1. Date of Application: 12/9/21
2. Date of Plan or Revision: 11/30/21
3. Application for: Butler Ave Mixed Use
4. Name of Subdivision or Land Development: Butler Ave Mixed Use
5. Location: 409 W. Butler Ave
6. Tax Map Parcel #: 26-005-023 Total Acreage: Gross 7.3 Net 6.6
7. Net Buildable Site Area (from Section 2401): 6.6 acres
8. Zoning Requirements:

PRELIMINARY AND FINAL LAND DEVELOPMENT PLANS

RE: Fire Marshal review Butler Avenue Property T.P. # 26005-023

**BUILDING B - ADA ACCESSIBLE ROUTE
(NE - ENTRANCE)**

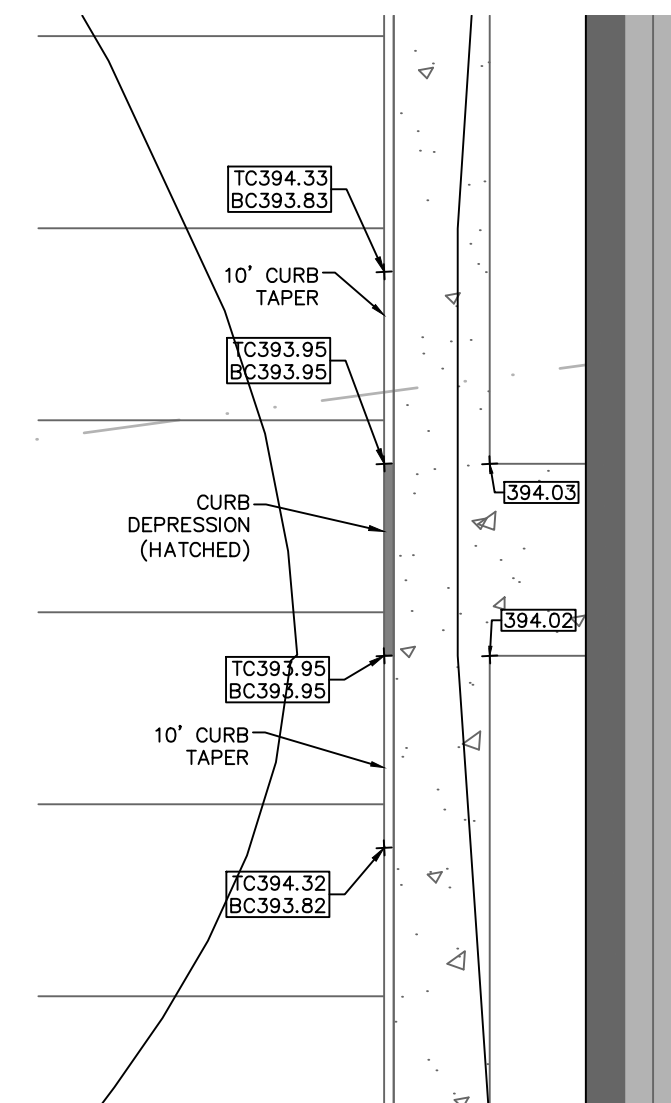
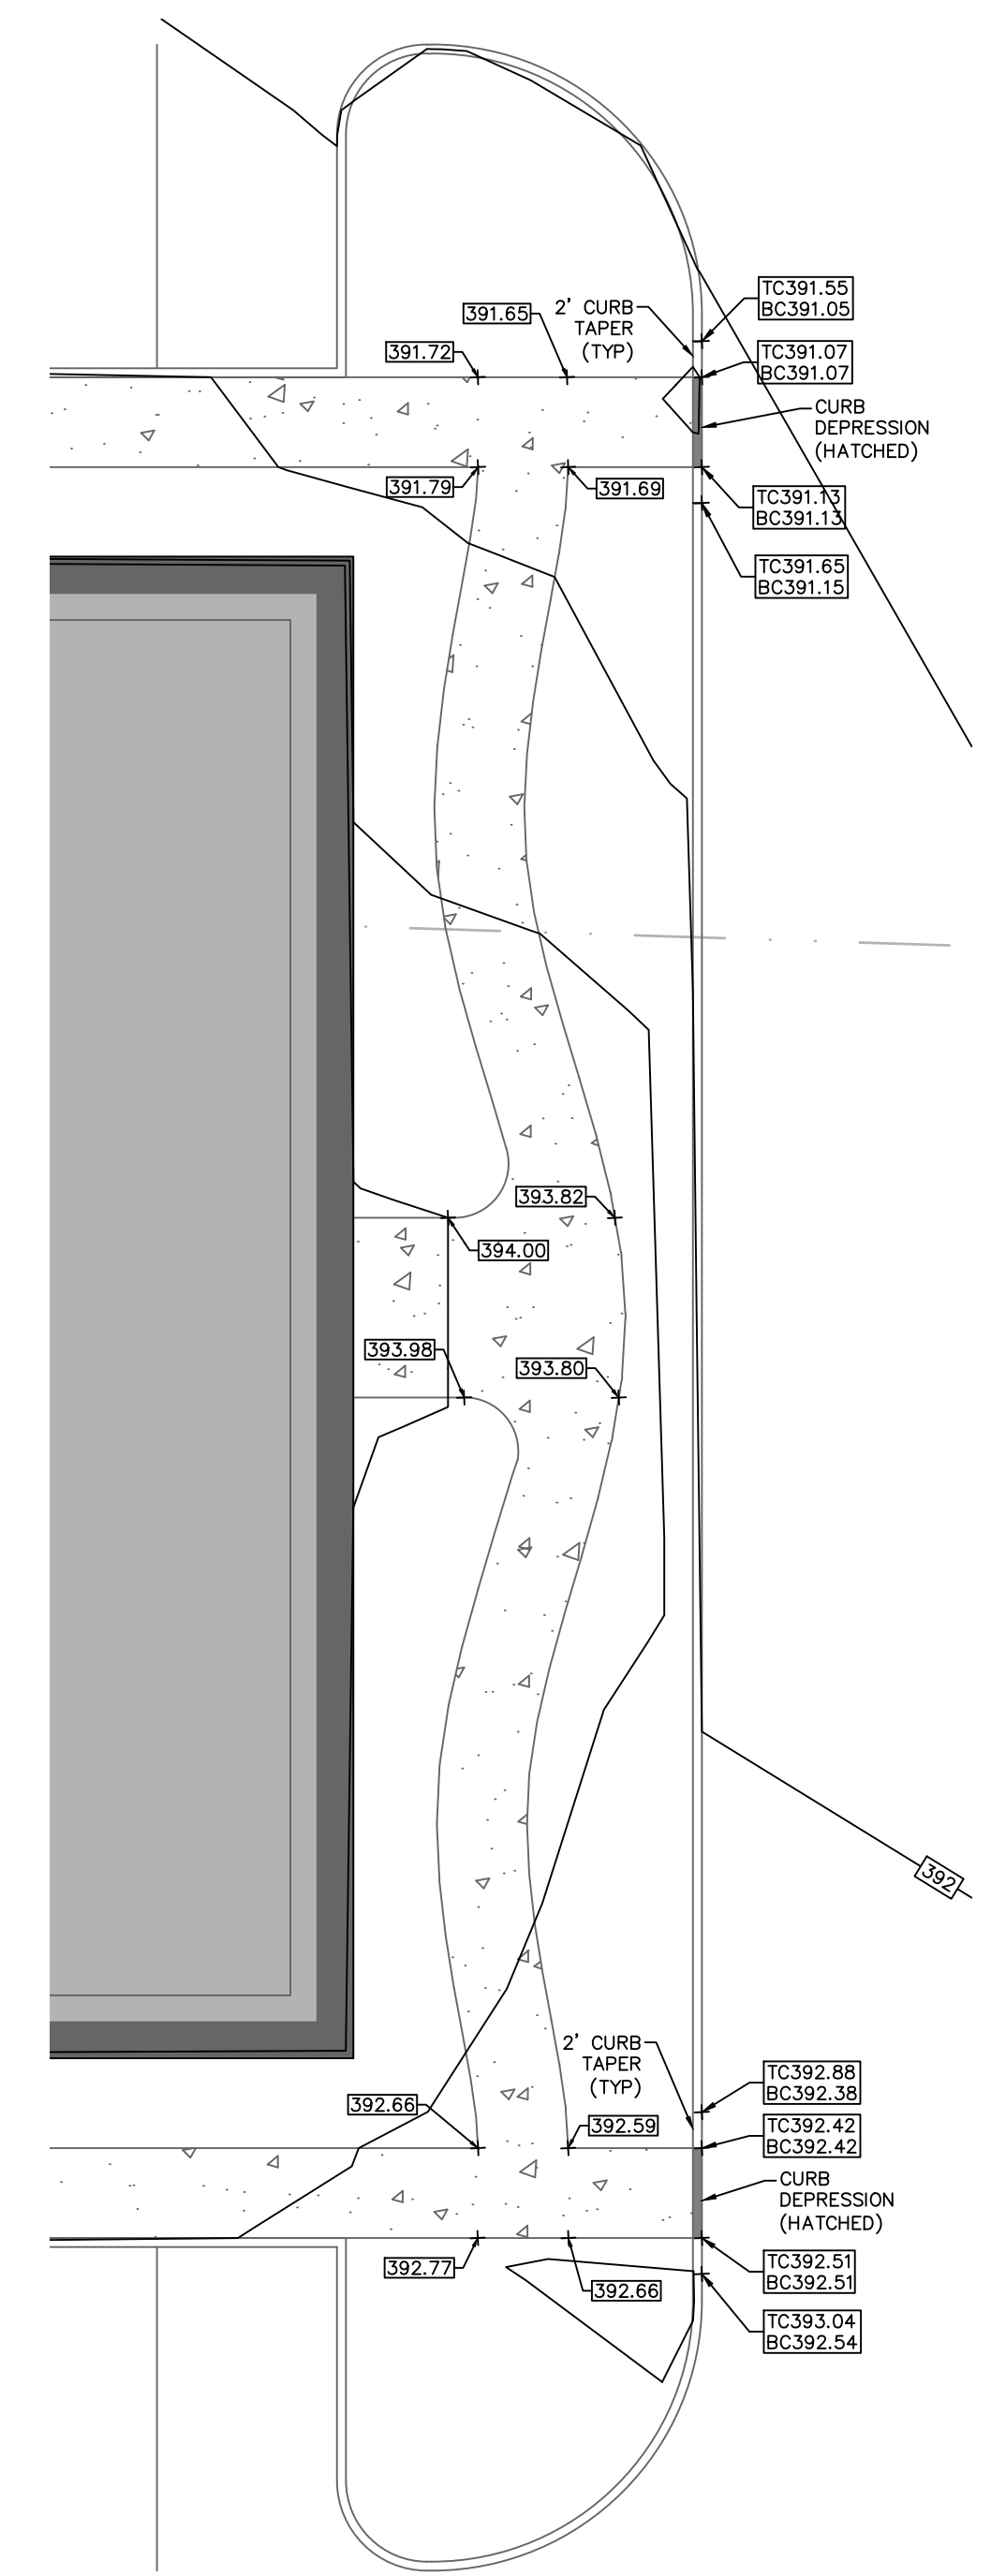
8. §27-2904.d.3 – Access driveways shall have a 6% maximum grade, except that the initial 20 feet from the edge of the cartway of a public street shall be a maximum of 3% grade. Based on the curb elevations on Sheet 7, it appears the initial 20 feet from the cartway may exceed 3%, while the remainder of the driveway has a slope of approximately 6.7 to 7.5%. The driveway grading shall be verified to clearly meet the minimum required driveway slopes.

BUTLER AVENUE PROPERTY
 TMP # 26-005-023
 NEW BRITAIN TOWNSHIP, BUCKS COUNTY, PA
LANDSCAPE PLAN

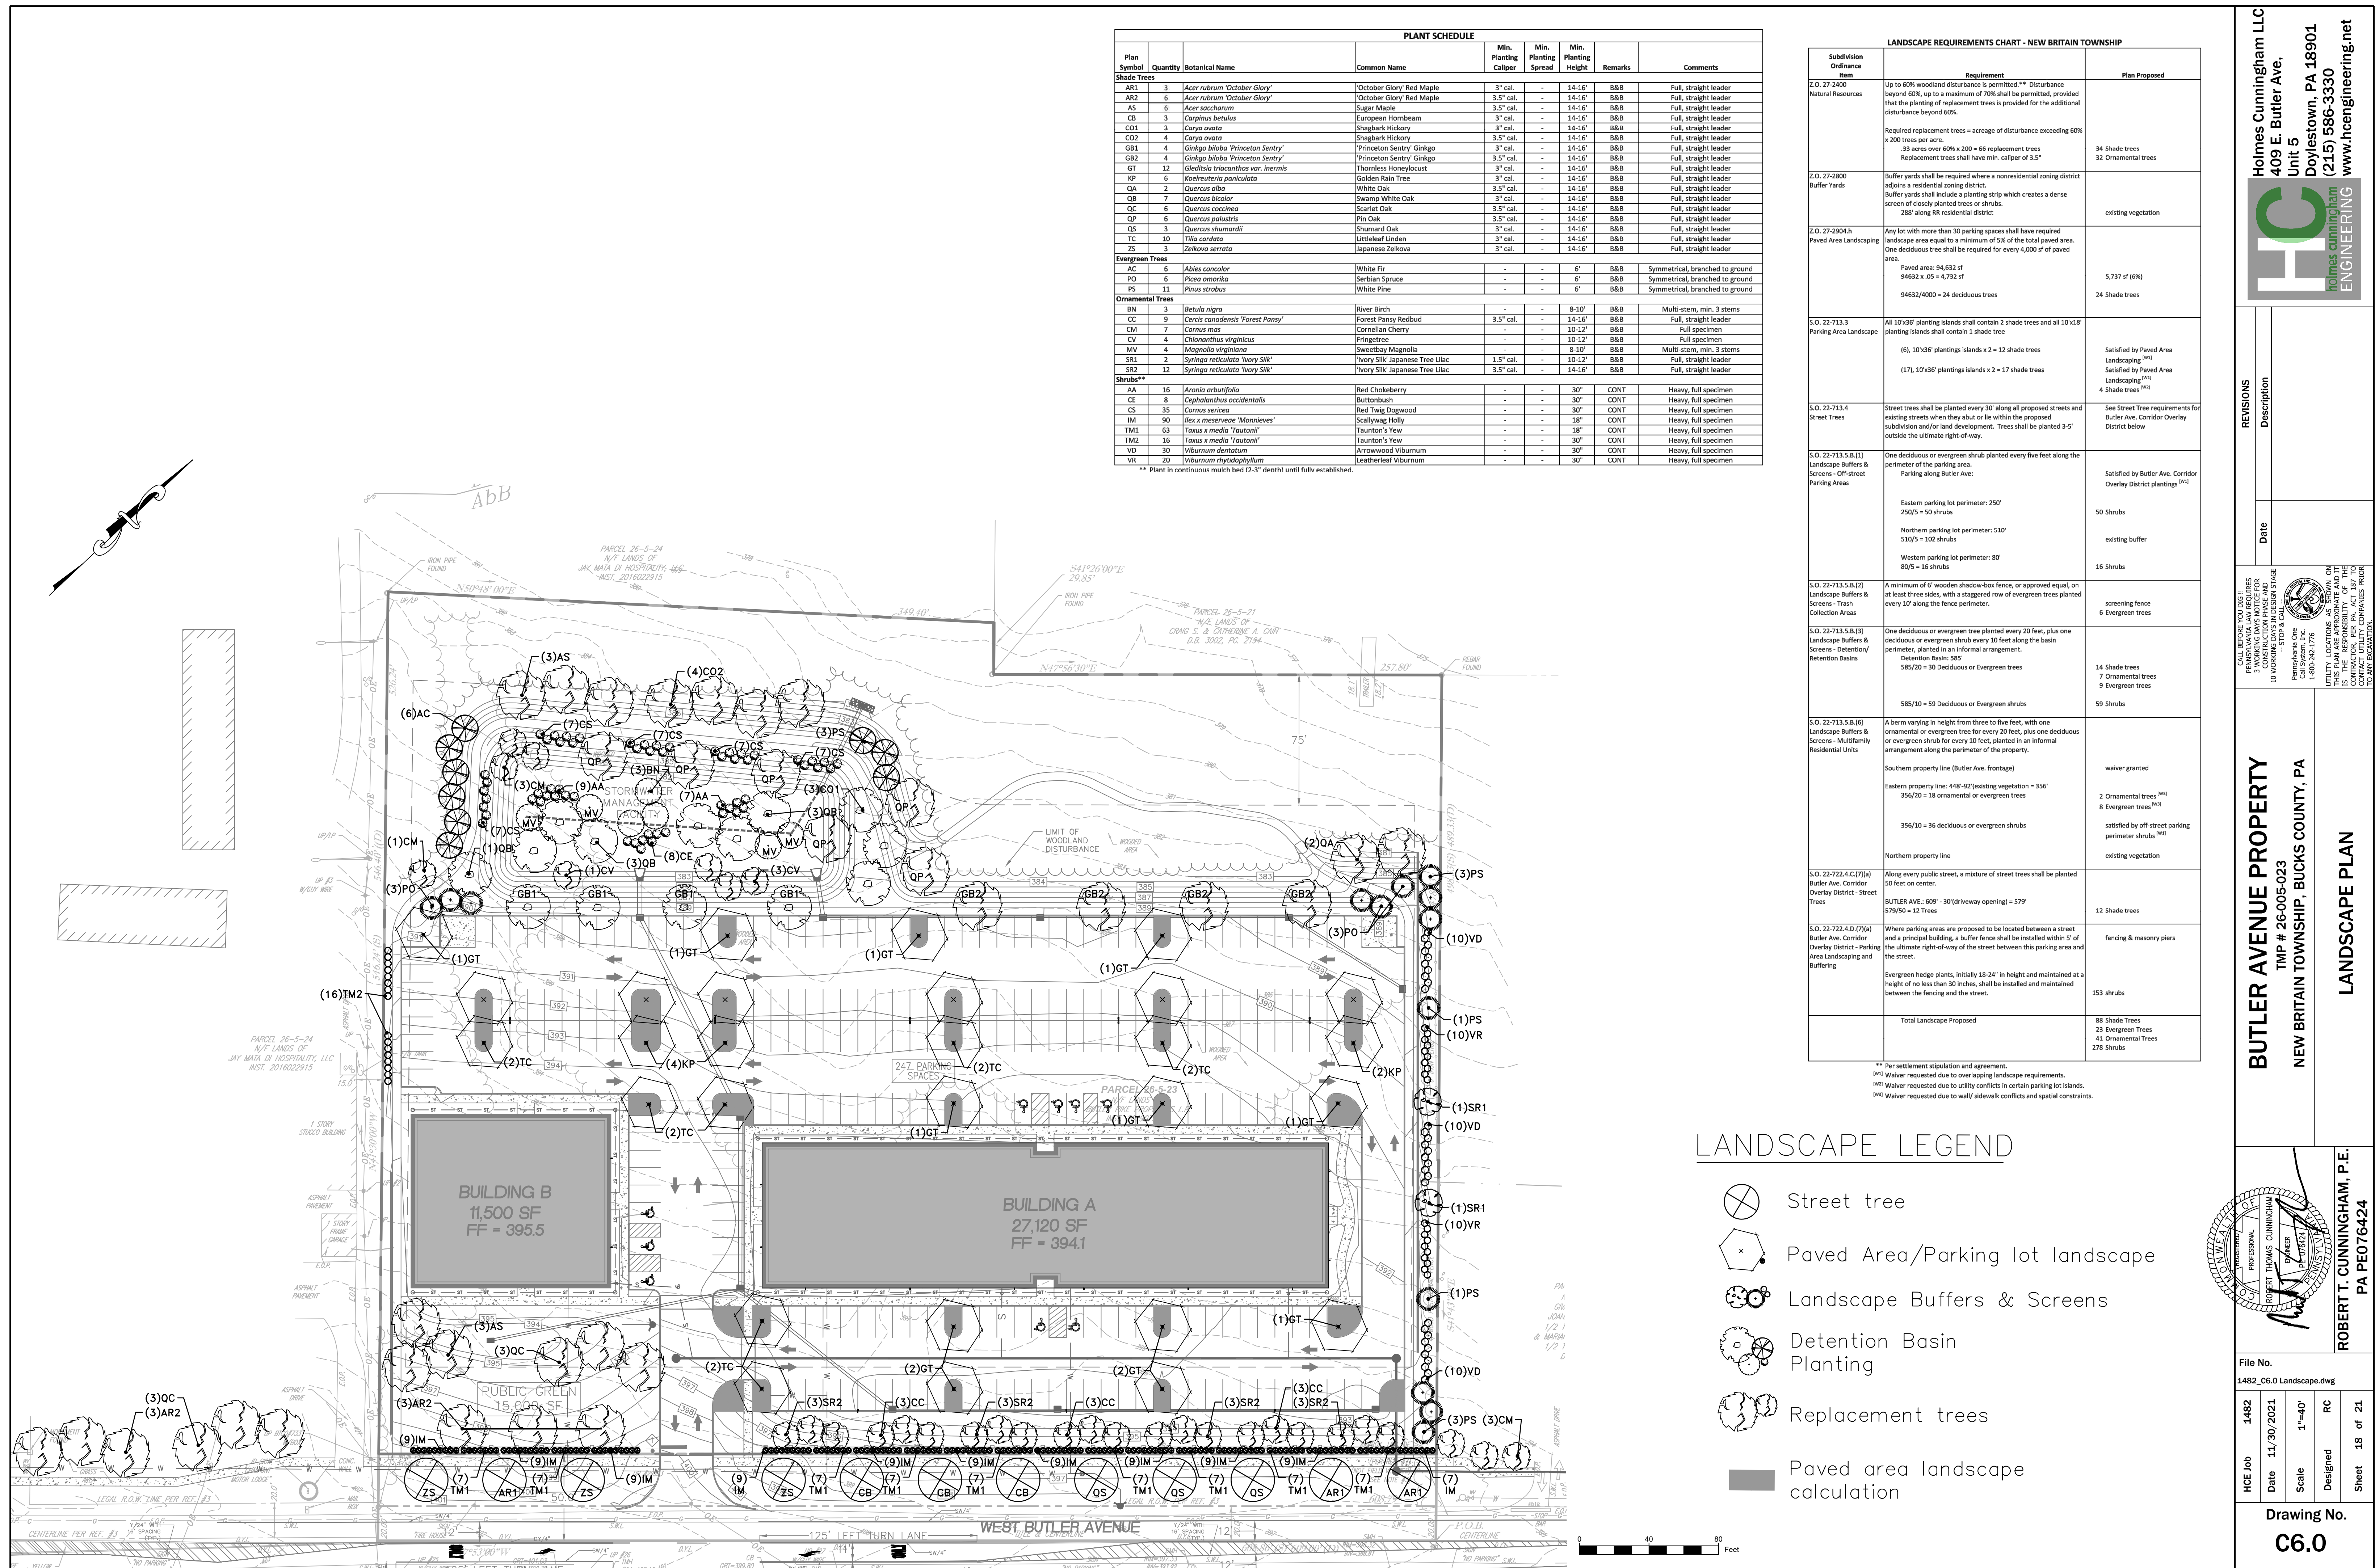
- b. The Plant Schedule provided on Sheet 18 of 21 Landscape Plan indicates a quantity of 90 Scallywag Holly, whereas the plan shows 97. The plan and schedule shall be coordinated.

SETTLEMENT PLAN
 NEW BRITAIN TOWNSHIP, BUTLER COUNTY, PA
 THE 26.008.023
BUTLER AVENUE PROPERTY

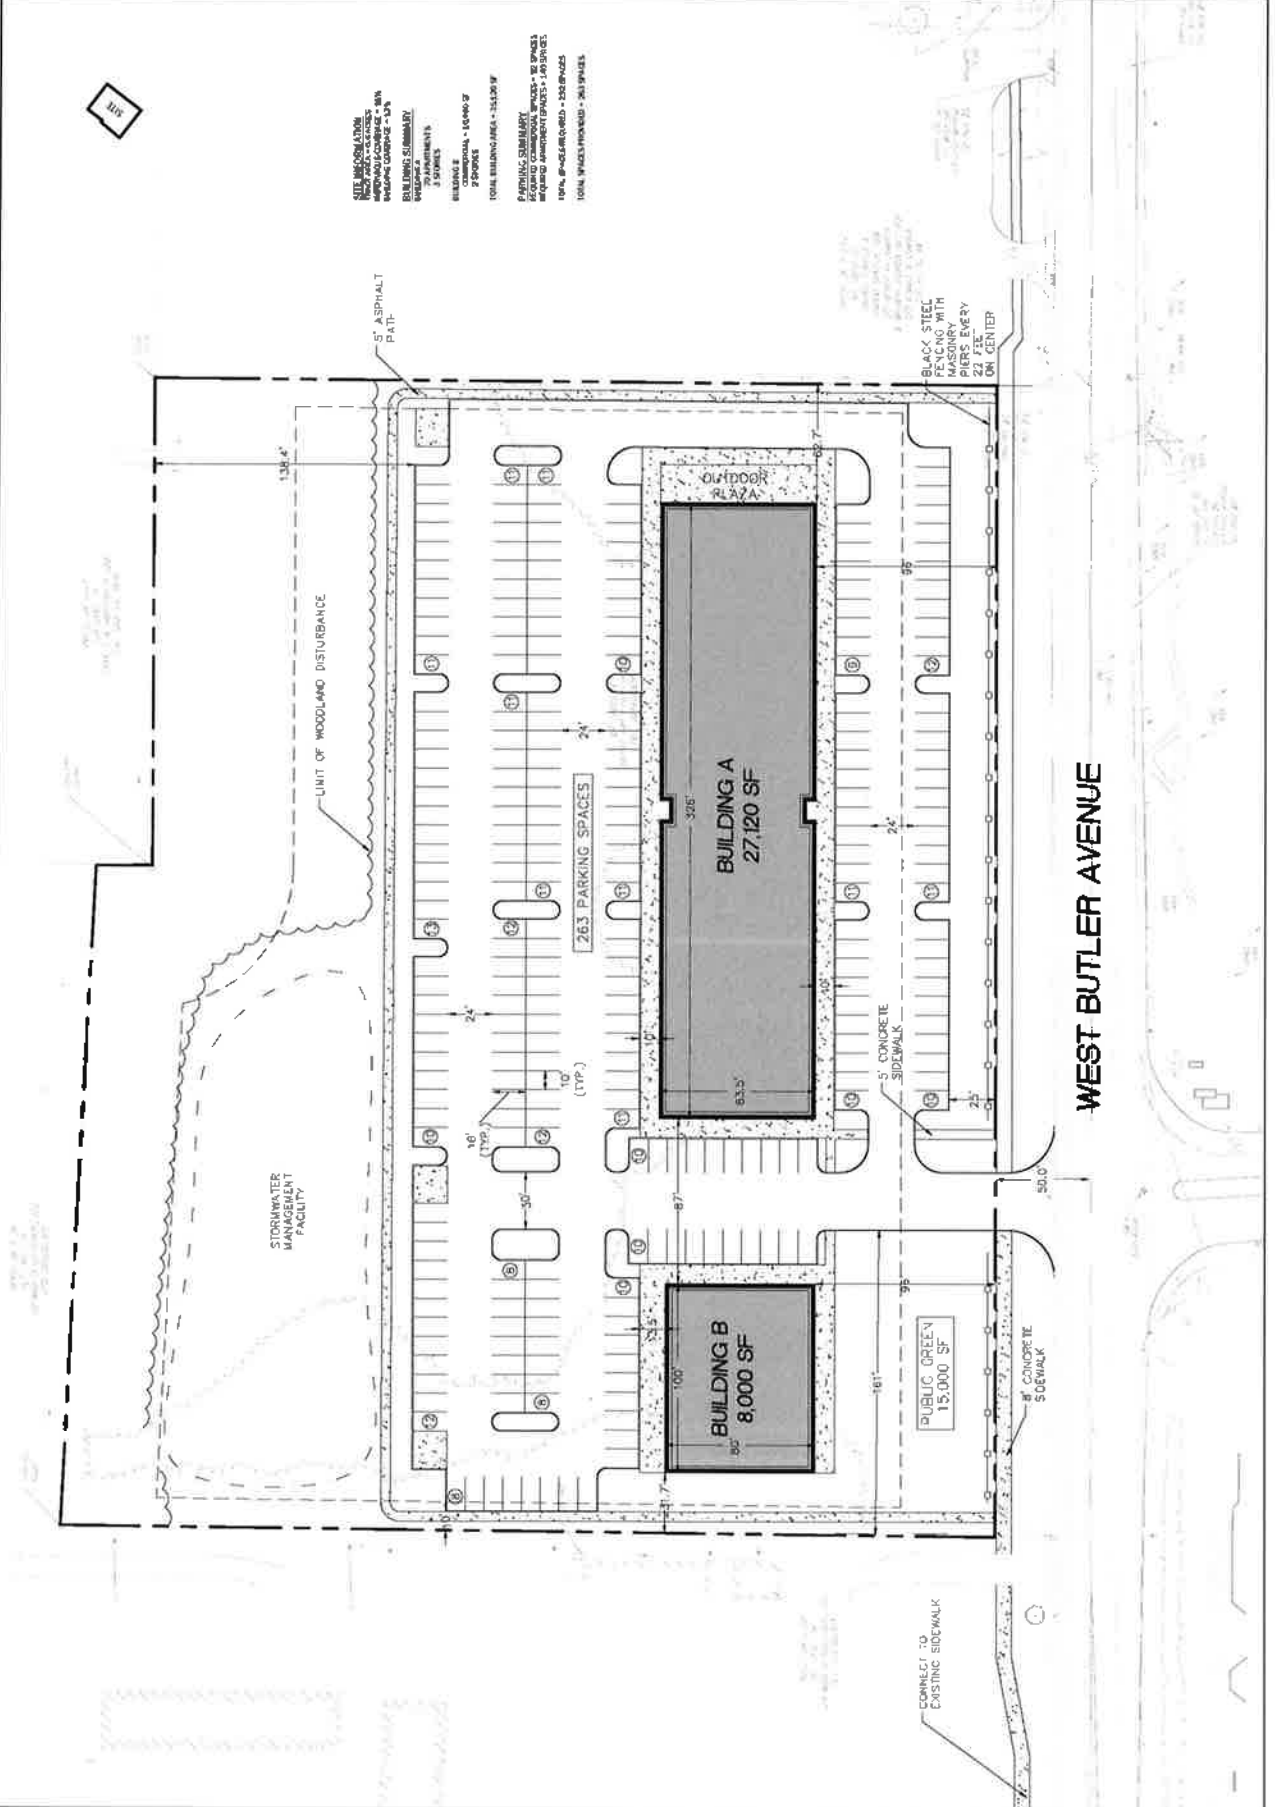
3. Stipulated Agreement #9.d. – The Property Owner identifies the Public Green at the Butler Avenue frontage. However, SALDO §22-722.4.G requires green spaces to contain shrubs and trees, public benches, and some type of public amenity, such as gardens, sculptures, gazebos, or fountains. While the proposed Public Green provides 9 shade trees (3 Red Maple, 3 Sugar Maple, and 3 Scarlet Oak per Sheet 18 of 21), shrubs, benches and an amenity shall be provided as approved by the Board of Supervisors (Board).

8. Stipulated Agreement #15 – Additional disturbance beyond 60%, up to a maximum of 70% of the woodlands on the Property, shall be permitted, provided that the planting of replacement trees is provided for the additional disturbed area beyond 60%. The Resource Protection Calculations on Sheet 4 of 21 indicate that 31.1% of the woodlands is being protected which equates to 68.9% disturbance. Therefore, 8.9% of woodlands requires 66 replacement trees based on 0.33 acres at 200 trees per acre. We note that the the woodlands disturbance area does not consider trees that were certified as dead by an arborist. In addition, there are individual trees within the front yard that do not appear to be considered woodlands. Finally, the calculation does not include disturbance required for the perimeter asphalt trail as it's noted to be field located to avoid tree disturbance. We recommend a site meeting to determine if the existing, living trees have a continuous canopy and if the trail can be installed without disturbing the woodlands required to be protected.

9. Stipulated Agreement #15.d. – The individual planting location and the specific species of each replacement tree shall be determined by the Township. The plans propose 34 Shade Trees and 32 Ornamental Trees for a total of 66 trees per Sheet 18 of 21. It shall be clarified which plantings are proposed to satisfy the tree replacement requirement and the Board shall approve the locations and species.
10. Stipulated Agreement #16 – The date of the Settlement Stipulation and conditions #3, #4, #6, #7, #8, #13 and #14 related to variances and waivers granted, approved zoning uses for Buildings A and B, and required fees which supercede the Township code, shall be noted on the plan.
